**Section 96(1A) Modification Application (MOD 3) to State Significant Development 5169
Horsley Drive Business Park – Subdivision and Infrastructure Works
Corner of The Horsley Drive and Cowpasture Road, Wetherill Park**

This application has been prepared to modify State Significant Development 5169 to consolidate proposed lots 5 and 6 within Horsley Drive Business Park pursuant to Section 96(1A) of *the Environmental Planning & Assessment Act 1979*.

Figure 1: Estate Masterplan (as modified under MOD 2)

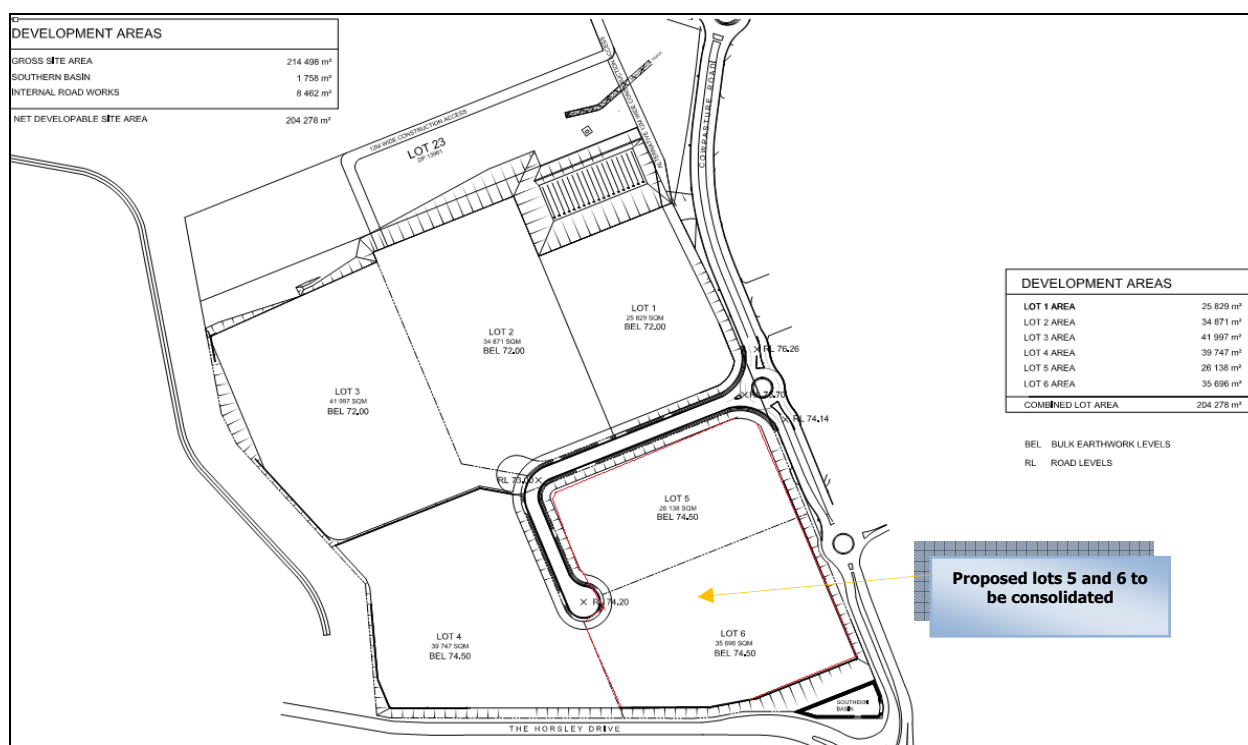
The subject application seeks to consolidate proposed lots 5 and 6 in order to accommodate the proposed Martin Brower Warehouse/Distribution and Industrial Facility that has been submitted to the Department of Planning and Environment (SSD 7078).

Accordingly, the proposed Estate now seeks consent for a 5 lot subdivision, and should be noted within the modified Instrument of Approval. The proposed subdivision is unchanged in staging and phasing as proposed in Mod 2. All infrastructure proposed for the subdivision to support the Mod 2 scheme remain
